## PROJECT BRIEF

*Historic District Board of Review Application for Certificate of Appropriateness at 407 W. Second St. to replace existing flat roof over entrance with pitched roof; replace flat roof on garage with pitched roof; build addition to **existing** garage of approximately 6'3" (with option to do garage or carport); replace existing wood windows with aluminum clad windows (front window & some side/rear window sizes will change); replace front door.*

HDBR Meeting Date: April 24, 2023

## HDCA-23-41

1 ROOF PLAN  
1/4" = 1'-0"

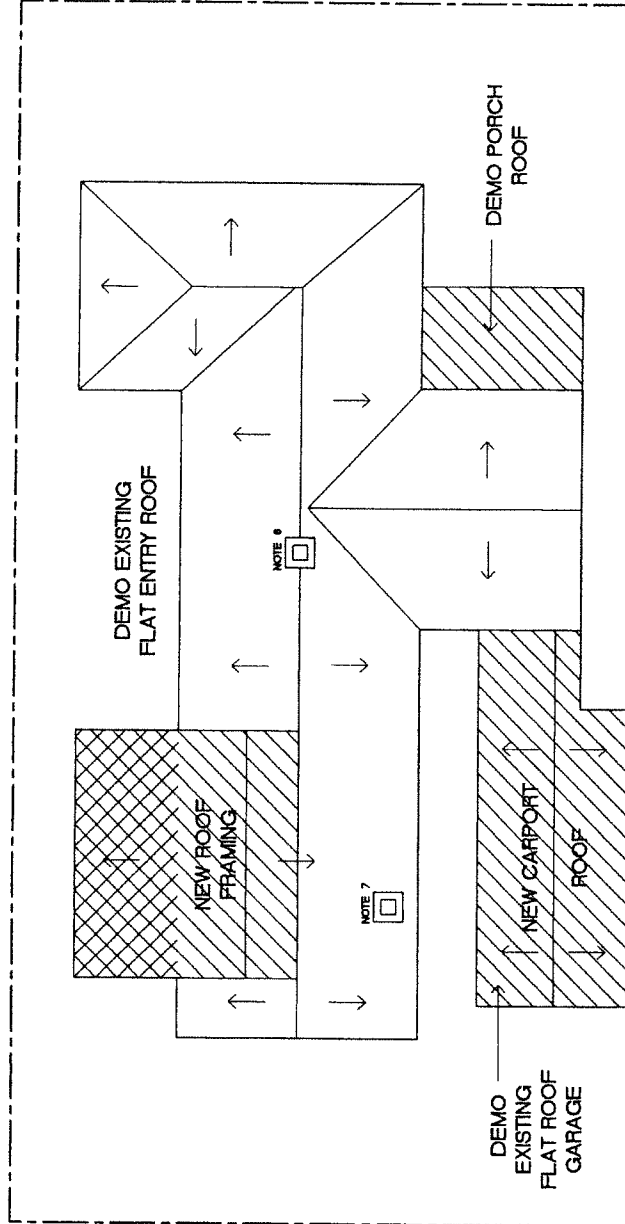
The project *is in* conformance with Guideline 3.9 because the proposed Cementous siding will help to restore a more accurate (not exact) representation of the original wood siding (that has been removed); is *not in* conformance with Guidelines 15.1, 15.3, & 15.11 because the proposed gabled roof will alter the historic character of the c. 1930 garage's flat roof design that featured wooden ornamentation railing to match the eastern entry addition roof detailing (this detailing was removed some years ago but was present in the Lemen photo taken in 1947); *is in* conformance with Guidelines 18.4, 18.7, & 18.8 because the proposed bay window will retain the character of the modification that has now gained historic significance as a prominent feature of the primary facade; *is not in* conformance to Guidelines 18.4 & 18.7 because the proposed new aluminum clad replacement windows will not retain the original size of the existing windows (in some locations); *is not in* conformance with Guidelines 26.1, 26.3 & 26.7 because the proposed new addition will be located on the front of the historic structure, will not be compatible in terms of details, and will not have a similar form or pitch; *is in* conformance with
